## Product Change Notification / JAON-18QNOS381

CCB 5014.004 and 6257 Final Notice: Qualification of a new die size (1.932x1.860mm) for Die #1 of selected Microsemi LE9653AQC, LE9653AQCT, LE9621AQC, LE9643AQC, LE9621AQCT, and LE9643AQCT catalog part numbers (CPN) available in 36L VQFN (4x6x1mm) package assembled at MMT assembly site.

**CCB 5014.004 and 6257**  
**Pre and Post Change Summary**  
**PCN#: JAON-18QNOS381**

**QUALIFICATION REPORT SUMMARY  
RELIABILITY LABORATORY**

# Pre and post change comparison

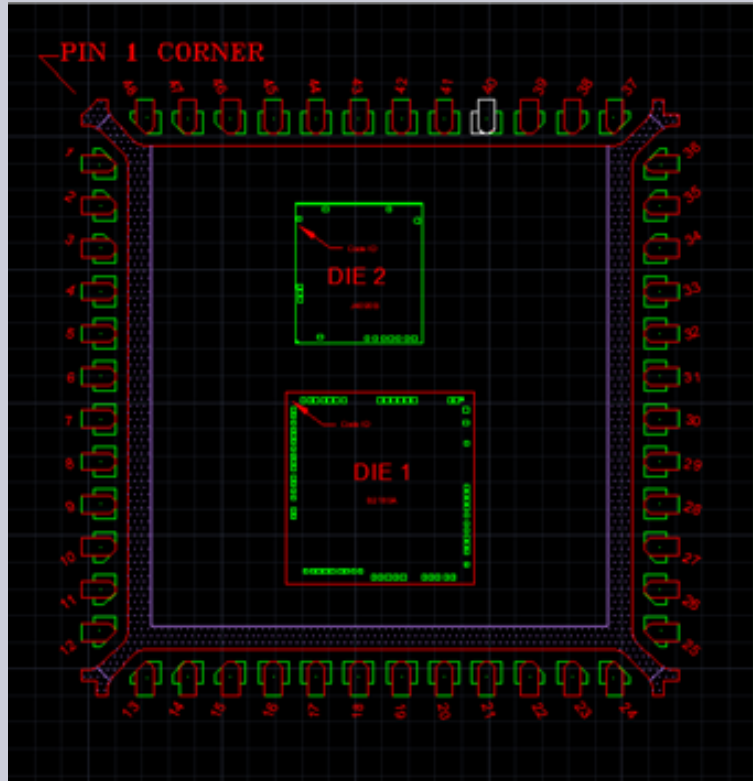
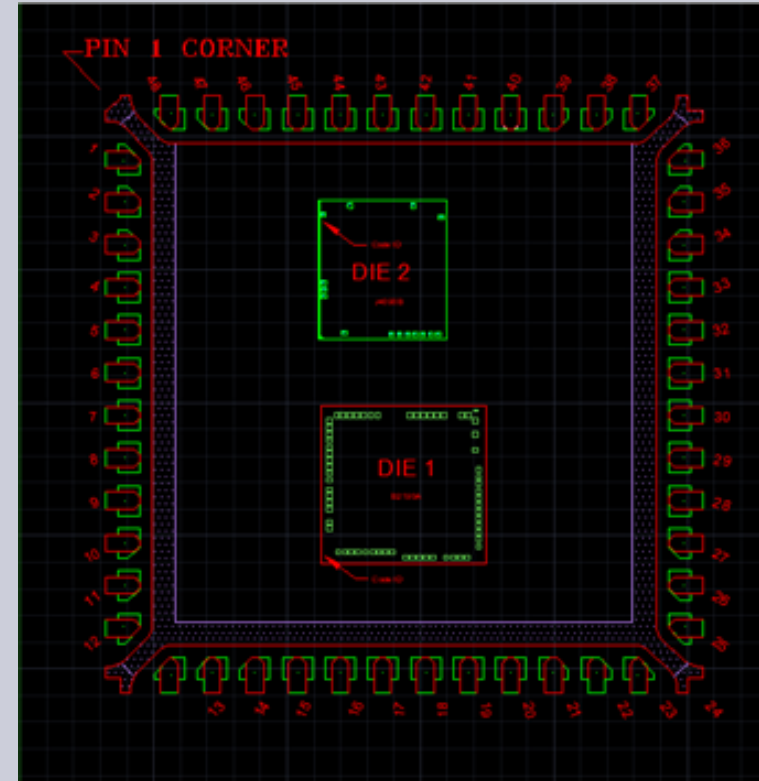
**Description of Change:**Qualification of a new die size (1.932x1.860mm) for Die #1 of selected Microsemi LE9653AQC, LE9653AQCT, LE9621AQC, LE9643AQC, LE9621AQCT, and LE9643AQCT catalog part numbers (CPN) available in 36L VQFN (4x6x1mm) package assembled at MMT assembly site.

**Reason for Change:**To improve productivity by qualifying a new die size.
